DEPARTMENT OF THE NAVY
NAVAL FACILITIES ENGINEERING COMMAND
1322 PATTERSON AVENUE, SE SUITE 1000
WASHINGTON NAVY YARD DC 20374-5065

June 19, 2008

Assessment of ATSDR Water Modeling for Tarawa Terrace

Figure 1. Simulated and measured concentration of tetrachloroethylene (PCE) in finished water at the Tarawa Terrace water treatment plant (from Tarawa Terrace Chapter A report).

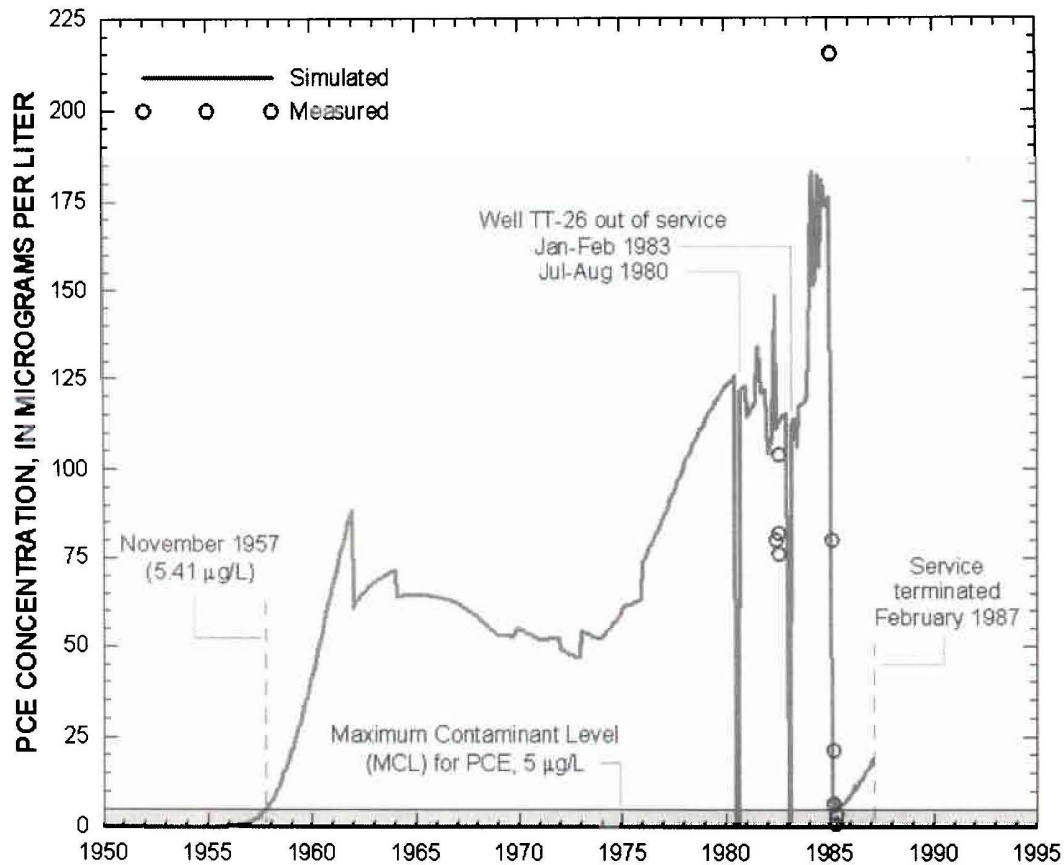
Figure 1 shows the simulated concentrations of PCE versus measured concentrations in finished water from the WTP. Significantly, measured concentrations of PCE are available only in 1982 and 1985, near the end of the overall time period. Thus, the majority of the simulated concentrations cannot be compared to measured data. Furthermore, all of the measured concentrations were used during model calibration, leaving no data available for model validation. As a result, the Tarawa Terrace model was not validated.

During calibration, model parameters were adjusted to cause the simulated concentrations at the Water Treatment Plant (WTP) to meet the calibration standard to the degree possible. For PCE detections, the ATSDR chose the calibration standard to be “ $\pm 1/2$ -order of magnitude of the observed value,” such that the higher value in the calibration target range is 10 times greater than the lower value. For example, at the WTP in May 1982, the calibration target range was 25 to 253 ug/L, based on the measured PCE concentration of 80 ug/L. The simulated concentration of 148 ug/L fell within this range. As another example, at supply well TT-26 in January 1985, the calibration target range was 500 to 5,000 ug/L based on the measured PCE concentration of 1,580 ug/L. In this case, the range was quite large because it was calculated from a relatively high measured concentration. The simulated concentration of 804 fell within the range, near the lower end. In summary, based on the chosen calibration standard, the calibration process was viewed as “successful” over a range that spanned a factor of 10. In other words, a model-derived PCE concentration can be approximately 3 times higher or 3 times lower than the measured concentration and still fall within the calibration range.

Thus, if all comparisons had fallen within the calibration range, the chosen calibration standard would give an idea of the accuracy, or degree of fit, between simulated and measured concentrations. However, all comparisons did not fall within the calibration range. At the WTP, 12% of the simulated PCE concentrations failed the calibration standard (p. F42 in the ATSDR modeling report). It should be noted that these failures involved non-detects or very low concentrations. More significantly, at the water supply wells, a majority (53%) of the simulated concentrations fell outside the calibration standard (p. F33 in the ATSDR modeling report). Graphs of simulated versus observed concentrations of PCE in water supply wells RW2, TT-23, TT-25, TT-26, and TT-54 are shown below in Figures F13 through F17 (p. F34 and F35 of the ATSDR modeling report). The graphs show that only a few observed PCE concentrations are available, and there are substantial differences between observed and simulated concentrations. Model performance at the supply wells raises concerns about the degree to which the model calibration was successful. It seems reasonable to conclude that the accuracy of historically
